AMENDMENT TO THE DRAWINGS

REMARKS

FIG 3

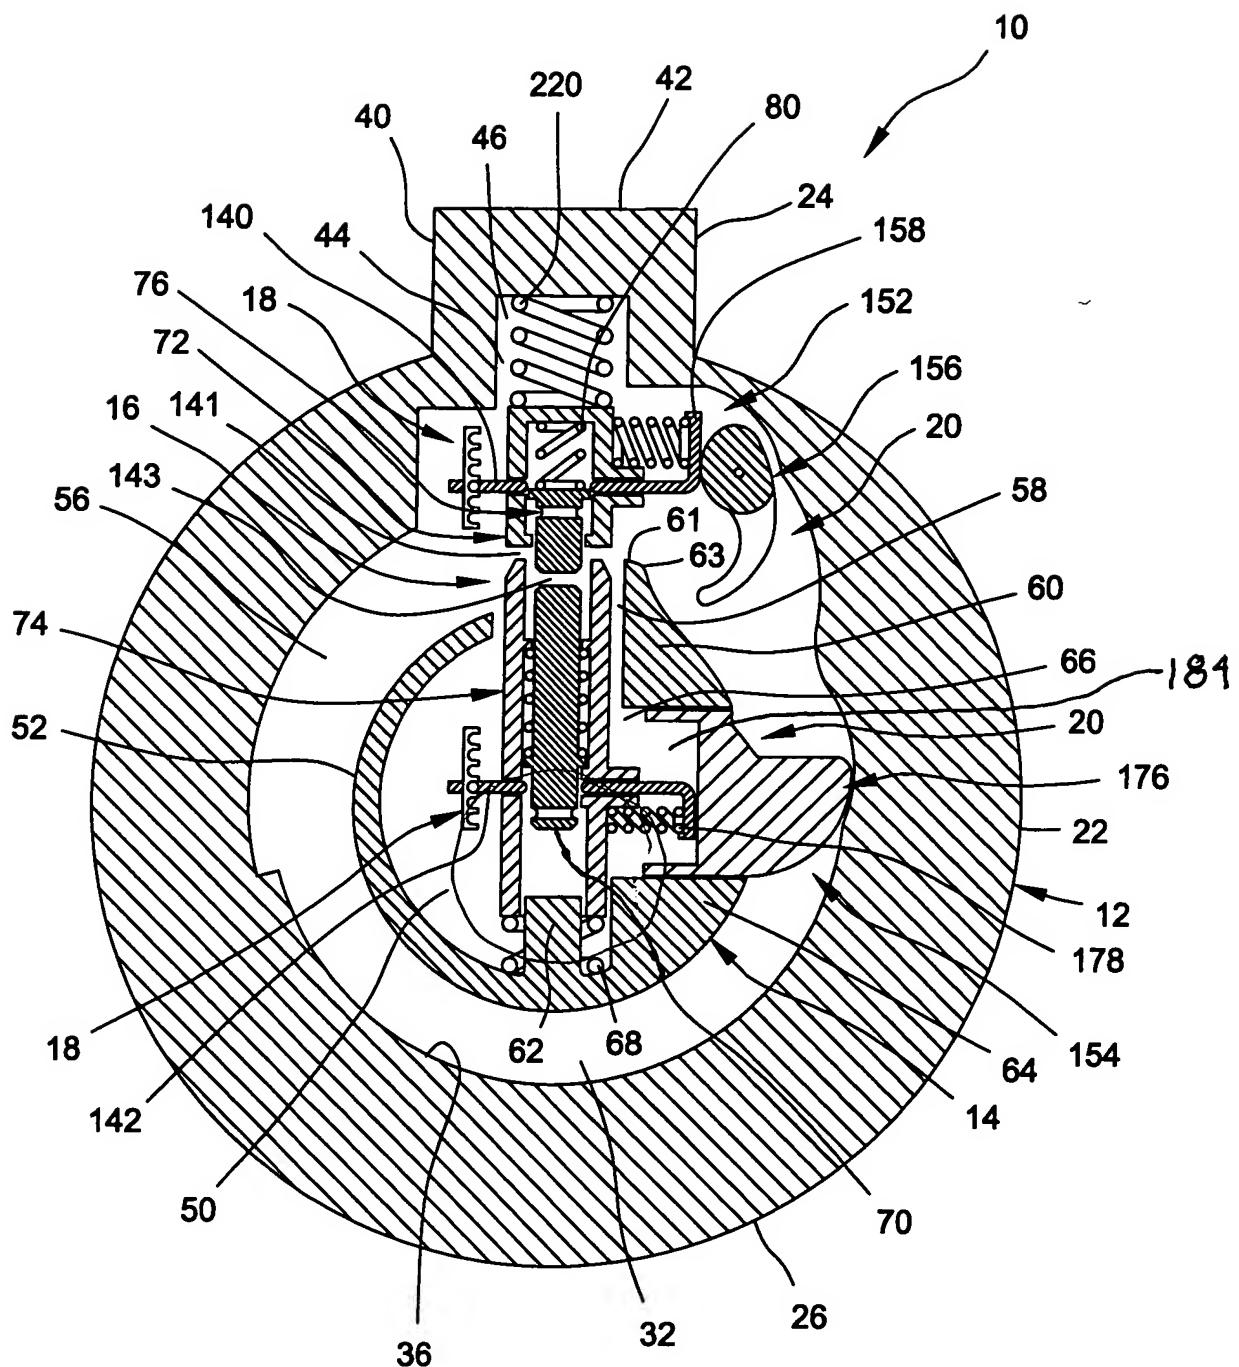
The third informality questions how surface 216 can contact surface 70 as seen in Figure 3, yet allow the key to engage the bottom of the pins as seen in Figure 2. Figure 3 is being amended to redirect the leader line from numeral 70, thereby obviating the objection, and Applicant respectfully requests withdrawal of the related objection.

Applicant submits herewith a copy of Figure 3 with proposed amendments in red. The numeral 70 is redirected to indicate the correct surface. Applicant also submits a replacement sheet incorporating the proposed amendments.
